ALERT SERVICE BULLETIN

NO. 427-10-30

MODEL AFFECTED: 427

SUBJECT: CARGO HOOK EQUIPMENT KIT P/N 427-706-900-101 AND -109 IMPROVEMENT OF.

Figure 1

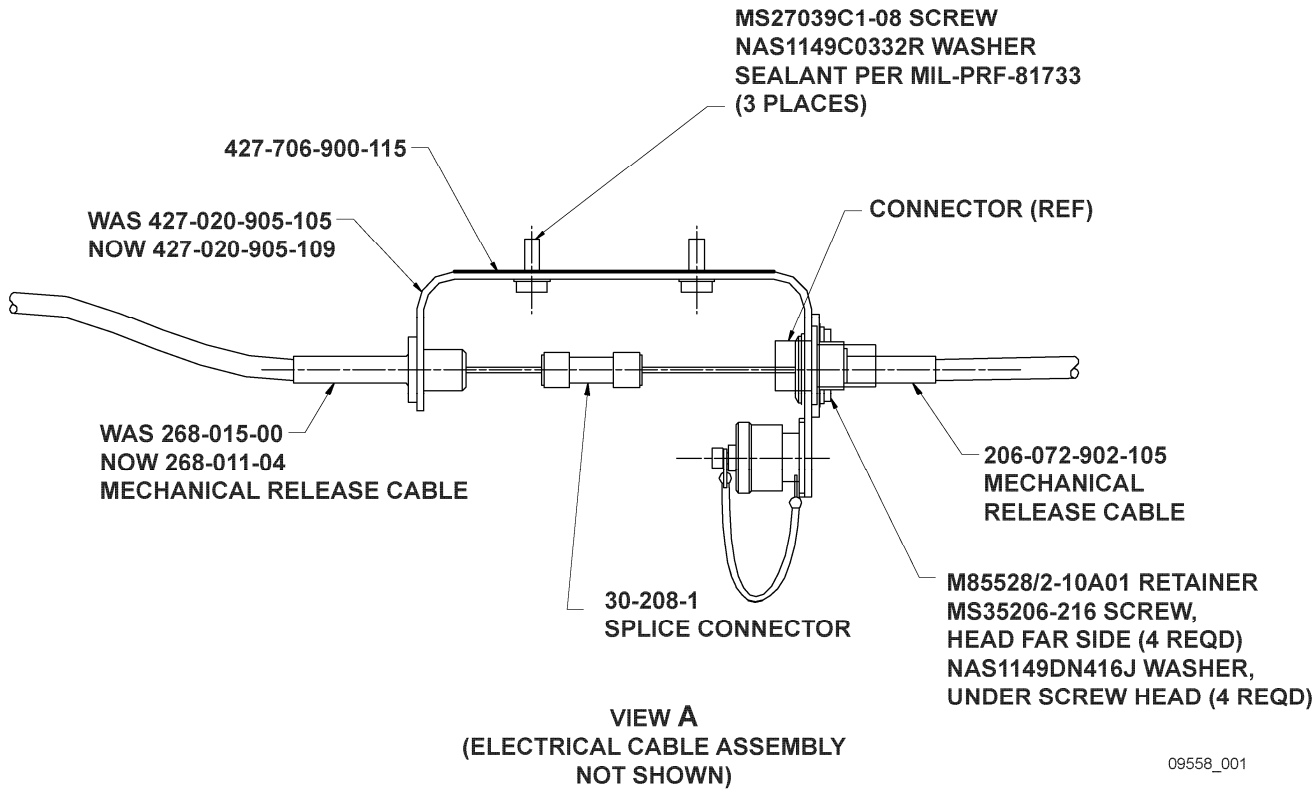
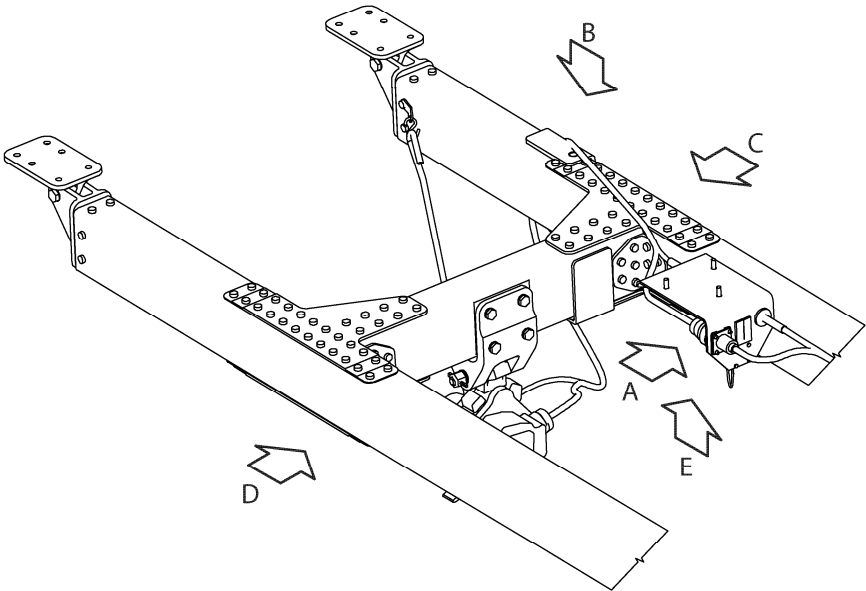
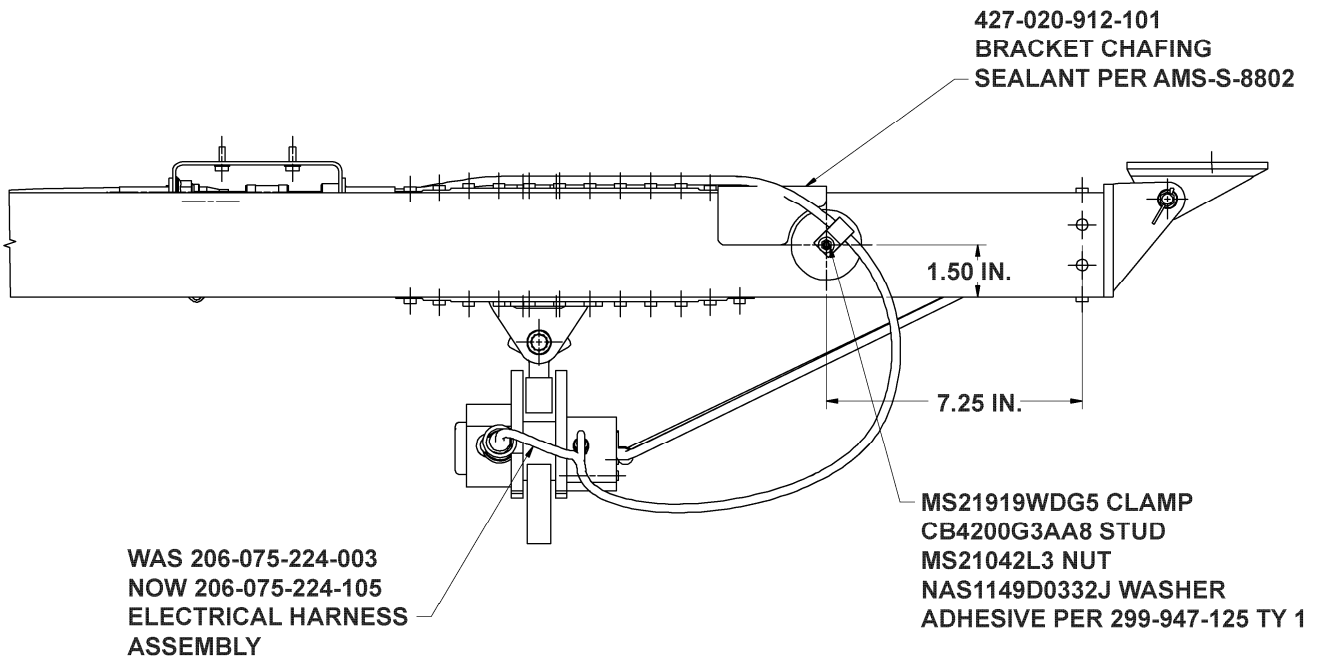
This bulletin provides instructions to replace the existing cargo hook manual release cable with new cable assy with modified routing and cable chaffing protection.

- a. Locate pad P/N 427-706-900-115 to match footprint of support assy P/N 427-020-905-109 and seal faying surfaces of support assembly using sealant MIL-PRF-81733 (C-392). Refer to figure 1 view A and 2 view B for location details.

- c. Edge seal around support assembly and pad with MIL-S-8802 sealant (C-308).
13. Connect the mechanical release cable P/N 206-072-902-105 to the support assy P/N 427-020-905-109 using retained nut and washer. Refer to figure 1 for location details.

18. Install splice P/N 30-208-1 linking the mechanical release cable P/N 268-011-04 to mechanical release cable P/N 206-072-902-105. Refer to figure 1 view A.

Figure 2

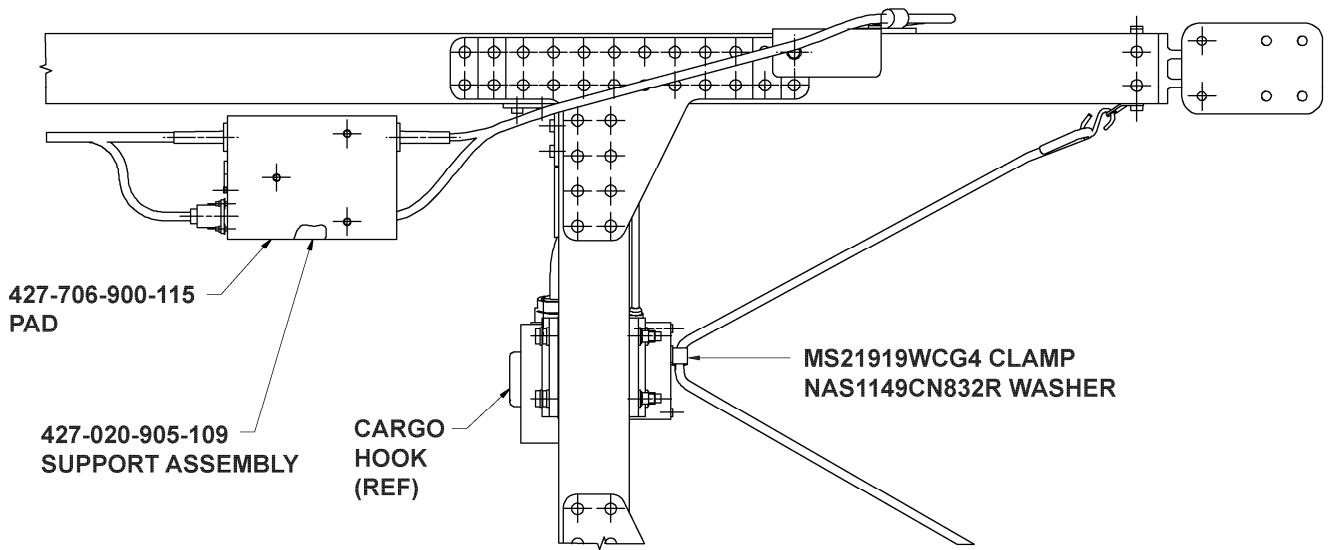
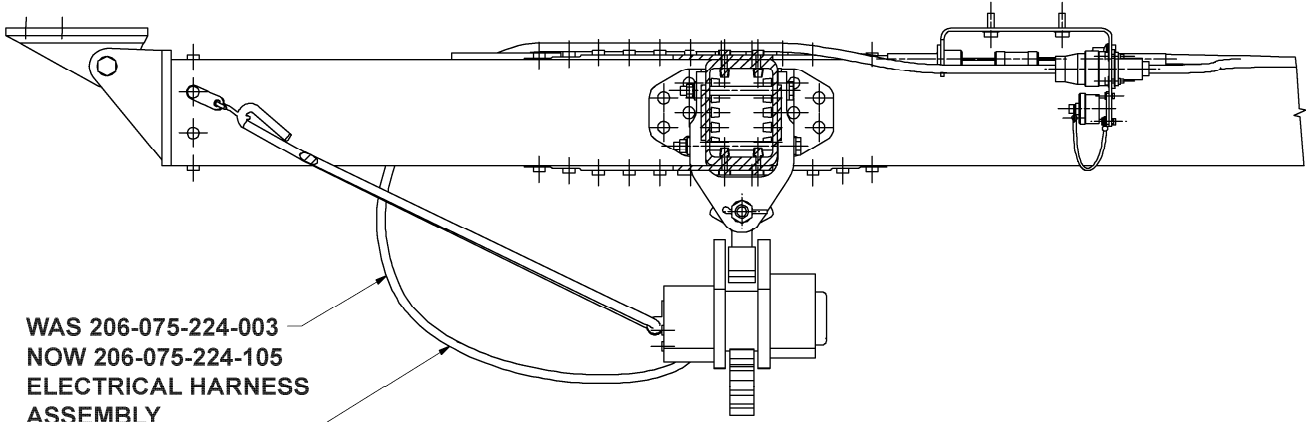
- a. Identify installation location of Click Bond stud P/N CB4200G3AA8 on frame assy P/N 427-020-901-101. Refer to figure 2 view C for location details.
- b. Remove paint finish to bare metal from installation location on frame assy P/N 427-020-901-101.
- c. Install click Bond stud using adhesive 299-947-125 TY1 (C-331) and allow curing. Refer to the BHT-ALL-SPM, chapter 13.
- d. Re-finish exposed metallic surfaces as required. Refer to the BHT-ALL-SPM, chapter 4.

19. Connect the new electrical harness assy P/N 206-075-224-105 connector (reference designator P181) to cargo hook P/N 528-010-00. Secure connector with lockwire P/N AS100026. Refer to figure 2 view C.

22. Attach the mechanical release cable P/N 268-011-04 and harness assy P/N 206-075-224-105 together to Click Bond stud P/N CB4200G3AA8 located on frame assy P/N 427-020-901-101 using clamp P/N MS21919WDG5, washer P/N NAS1149D0332J and nut P/N MS21042L3. Refer to figure 2 view C for location details.

WAS 206-075-224-003
NOW 206-075-224-105
ELECTRICAL HARNESS
ASSEMBLY

WAS 268-015-00
NOW 268-011-04
MECHANICAL RELEASE
CABLE

Figure 3

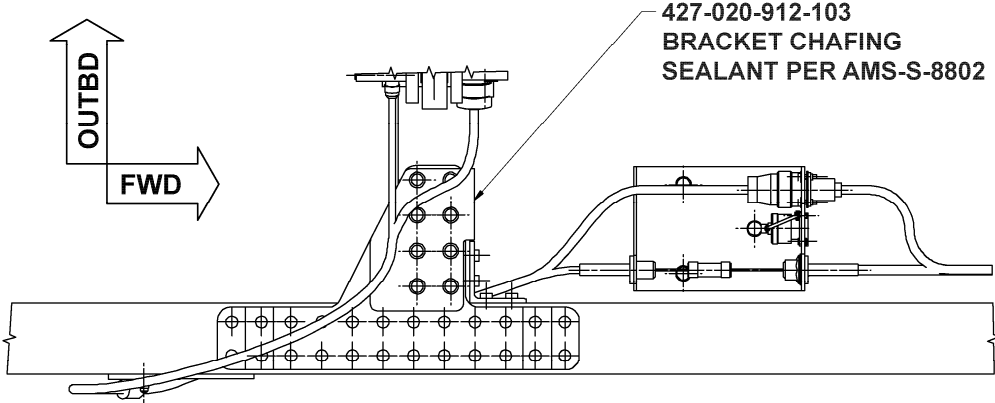
14. Secure the electrical harness assy P/N 427-076-021-107 receptacle (reference designator 2580J1) to the support assy P/N 427-020-905-109. Using quantity 4 screws P/N MS35206-216, washer P/N NAS1149DN416J and retainer P/N M85528/2-10A01. Refer to figure 1 view A and 3 view D for location details.

15. Connect the new mechanical release cable P/N 268-011-04 to cargo hook assy P/N 528-010-00. Refer to figure 3 for location details.
16. Install the shock cord P/N 206-072-905-103 using the retained clamp P/N MS21919WCG4 and washer P/N NAS1149CN832R. Install the cargo hook cover and secure with lockwire P/N AS100026.

427-020-912-103
BRACKET CHAFING
SEALANT PER AMS-S-8802
